Our reference: P-387860-Q0C5
Contact: Kathryn Saunders, Principal Planner
Telephone: (02) 4732 8567

**Modification Application - Aspect Industrial Estate
SSD-10448 - MOD-3**

Figure 2: Excerpt from At&I civil plan 18-596-C1013 Issue E – Typical Sections Sheet 4

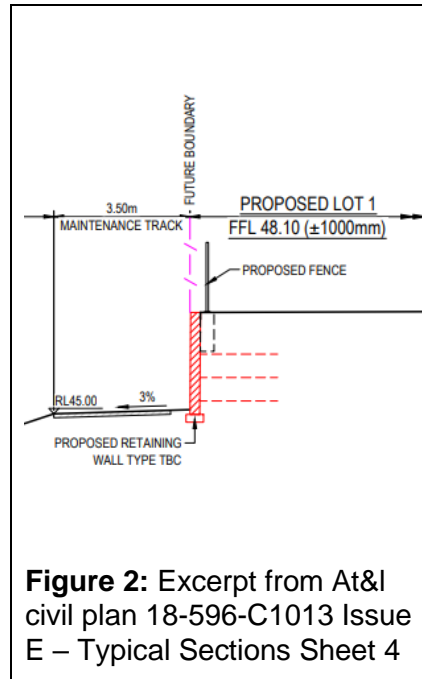
Civil sections across the estate include 1200mm wide concrete dish drains and catch drains within areas for landscaping which in some instances impact viability of proposed landscaping and canopy tree provision.

Civil sections indicate no planting at the boundary between Lot 1 and the basin maintenance track in conflict with the landscape plans (refer conflicting planting at Figure 1 and 2 below).

It is recommended that the applicant consider a more natural edge to the basin, with a battered retaining wall. Material selection is to be strongly considered as the western boundary of Lot 1 is significant in length and the development is to have a more elevated design presentation to Mamre Road.
